APPLICATION NO.	FILING DATE	FIRST NAMED INVENTOR	ATTORNEY DOCKET NO.	CONFIRMATION NO.
10/627,893	07/25/2003	Eric C. Hannah	42P12034D2	3477

Office Action Summary

DETAILED ACTION

FIG. 5

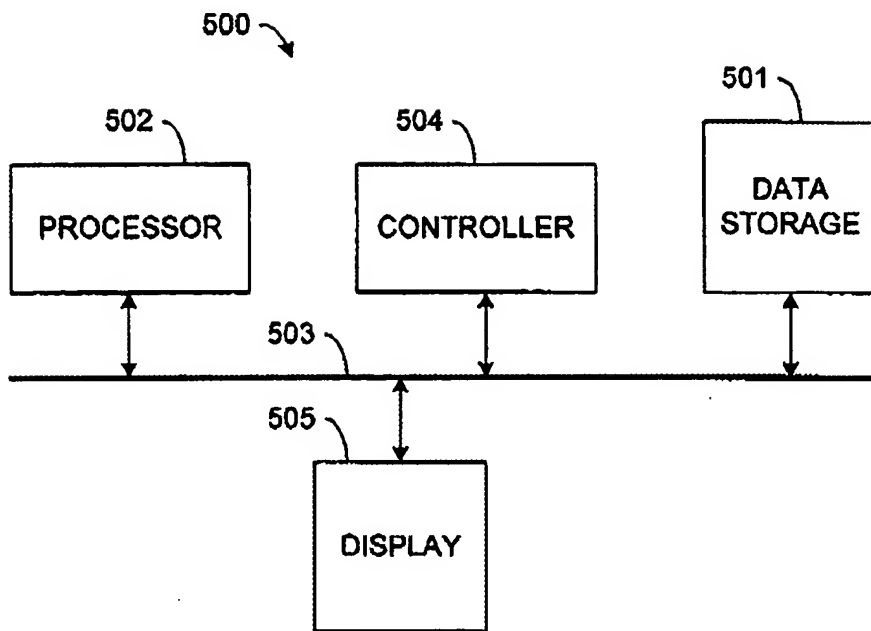
Approved
TP
3/19/06
